NATIONAL RADIO ASTRONOMY OBSERVATORY
Charlottesville, Virginia
February 7, 1986

TO: VLBA Electronics Group
FROM: Harry Dill
SUBJECT: Vertex Room Register Duct Placement

FIGURE 1

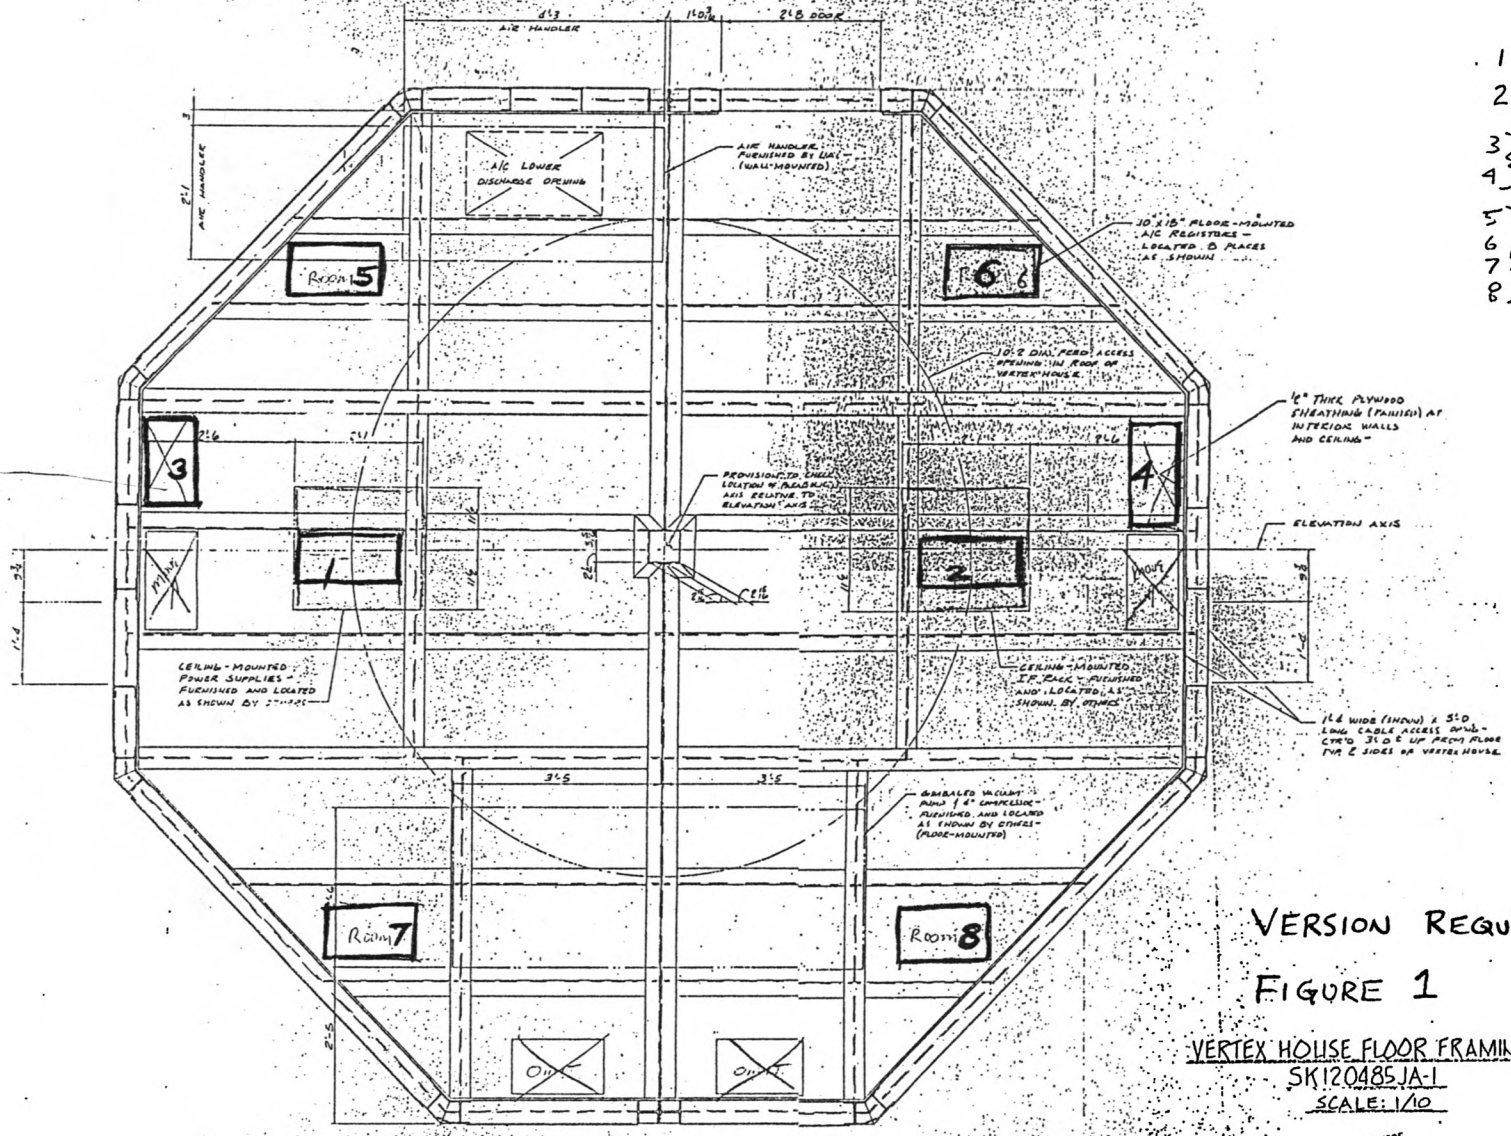
NRAO's vent placement proposal is as follows. Vent 1 is under the power supply rack. This rack is not a critical temperature area, but forced air flow will increase the convective heat transfer. Vent 2 is to be ducted to the base of the IF rack. This rack may need additional reheat at the rack base controlled by a thermostat placed at the top of the rack. This would allow better regulation of the air temperature flowing through the rack.

Vents 3 and 4 are moved from UAI's original placement because they will be used to duct air up into the upper equipment room area. Here again additional reheat may need to be added at the output. UAI's placement could have caused conflict between ducts to the upper area and cables coming through the side bulkheads.

Vents 5-8 are in UAI's original placement and will be used to duct air into the lower equipment room. They should be a louvered type of register that would allow some flow reduction through the registers.

VERSION REQUESTED BY NRAO 2-6-86
